Project	IEEE 802.16 Broadband Wireless Access Working Group < http://ieee802.org/16 >	
Title	Relay Station Handover Procedure	
Date Submitted	2007-03-05	
Source(s)	Hang Zhang, Peiyong Zhu, Mo-Han Fong, Wen Tong, David Steer, Gamini Senarath, Derek Yu, Mark Naden, G.Q. Wang	Voice: +1 613 7631315 [mailto:WenTong@nortel.com] [mailto:pyzhu@nortel.com]
	Nortel 3500 Carling Avenue Ottawa, Ontario K2H 8E9	
Re:	A response to a Call for Technical Proposal, http://www.ieee802.org/16/relay/docs/80216j-07_007r2.pdf	
Abstract	This contribution proposes RS handover procedure which is required when an RS migrates from the air-interface provided by one access station to the air-interface provided by another access station due to radio environment change or topology change, etc.	
Purpose	To incorporate the proposed text into the P802.16j Baseline Document (IEEE 802.16j-06/026r2)	
Notice	This document has been prepared to assist IEEE 802.16. It is offered as a basis for discussion and is not binding on the contributing individual(s) or organization(s). The material in this document is subject to change in form and content after further study. The contributor(s) reserve(s) the right to add, amend or

Figure XXX. RS HO process

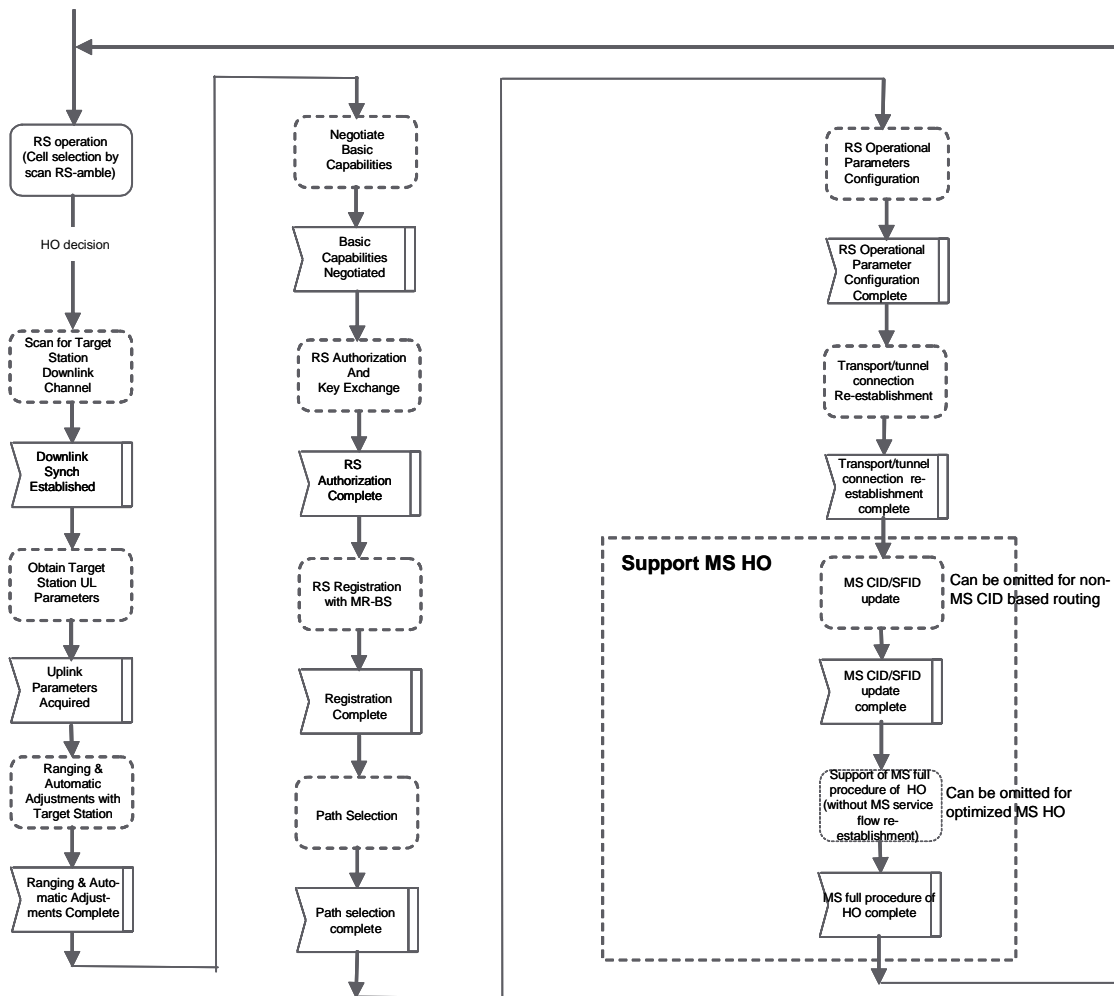
[Replace section 6.3.22.4 with the following]

This section defines the RS HO process in which an RS migrates from the air-interface provided by one access station to the air-interface provided by another access station. The RS HO process is depicted in Figure xxx.

The RS HO process consists of stages of MS HO process and following additional stages

- Path selection – This stage enable the target MR-BS to indicate a path re-reselection. The target MR-BS may decide to skip this step if the bit #0 in RS HO optimization TLV of MOB_BS_RSP/REQ is set

- RS operational parameter configuration – This stage enable the target MR-BS to reconfigure RS operational parameters. The target MR-BS may decide to skip tis step if the bit #1 in RS HO optimization TLV of MOB_BS_RSP/REQ is set

- Tunnel/connection re-establishment – this stage enable the target MR-BS to re-establish connection/tunnel for a RS. The target MR-BS may decide to skip this step if the bit #2 in RS HO optimization TLV of MOB_BS_RSP/REQ is set

- Support of MS HO stage is not required for RS in MBS mode and needed only for RS in MRS mode. This stage includes two sub-stages:
 - o Support of MS service flow re-establishment – This step is required only if MS CID based data forward is in use. In this case, this stage is used for the target MR-BS to inform the requesting RS regarding the CID/SFID updates of associated MSs/RS. For non-MS CID based data forwarding schemes, this step can be omitted. In this case, there is no MS CID/SFID is required. Since for DL data packet forwarding after the RS HO, the MR-BS can route the DL data packet of MSs associated with the RS to the tunnel/basic connection of this RS and no MS CID collision would happen.

- o Support full set of MS HO – This sub-stage can be omitted if optimized HO is possible. For non-optimized MS HO, the MS service flow re-establishment can always be omitted for non-MS CID based routing; for MS CID based forwarding, the RS may use CID swapping to avoid involvement of MS regarding the MS service flow re-establishment.
